Subject: Information on Hesitation and/or Misfire
Sensation When Passing Under High Voltage
Transmission (Power) Lines, - Multiple
Intermittent ABS DTCs Set

Models Chevrolet Express/GMC Savana

Origination October 30, 2025

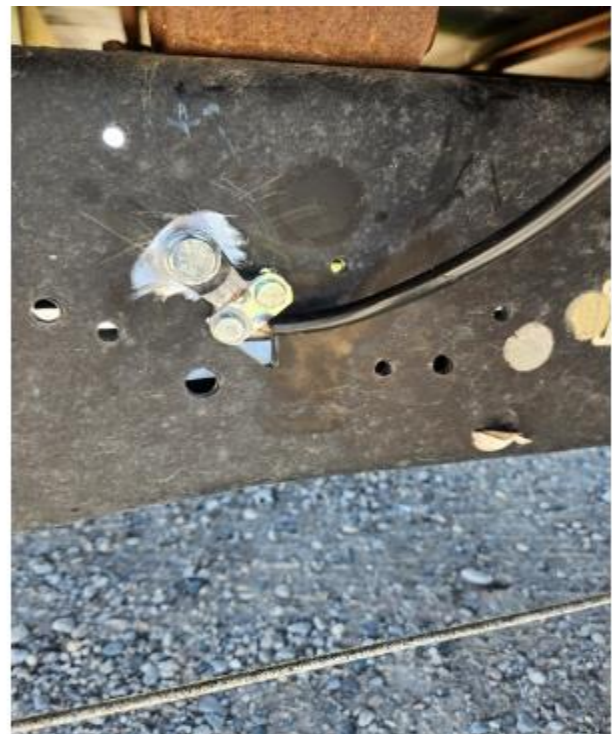
Ground cable installation across the first three roof bows. 7 feet of #4-gauge ground cable, attached to the bottom of the first three roof bows and then grounded to vehicle frame.

Prepare aluminum surface since it forms an oxide layer that is non-conductive, so, before installing the grounding, abrade the contact surface to bare metal and apply an antioxidant compound.

Frame Ground location prepared for terminal installation.

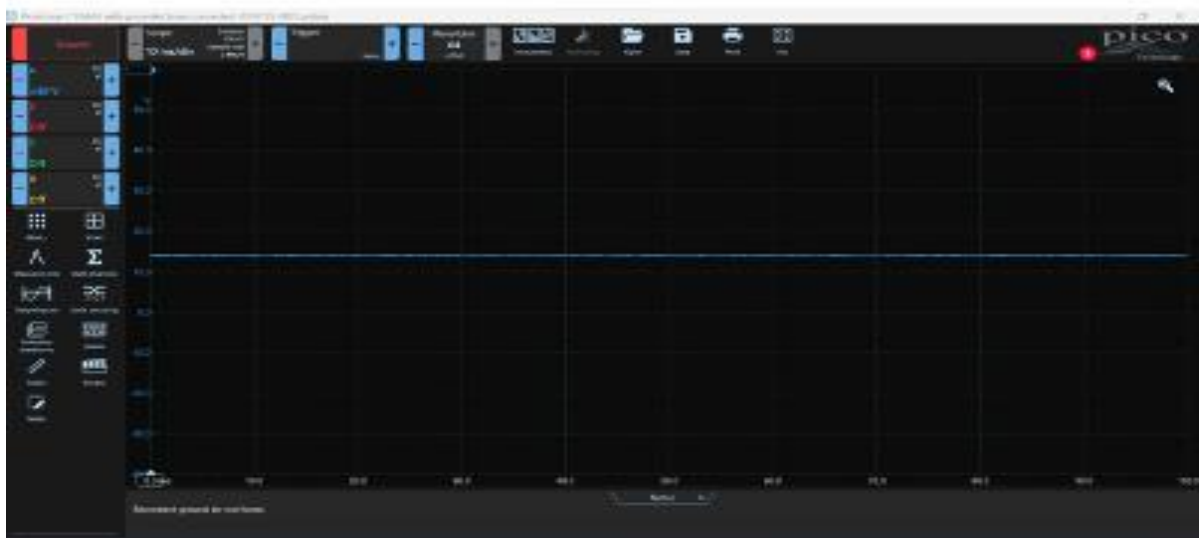
Attach end of ground cable to the vehicles frame and secure cable.

It is recommended to spray or coat the ground bolt/ring terminal on the frame with some anti-corrosion sealant to prevent rusting.
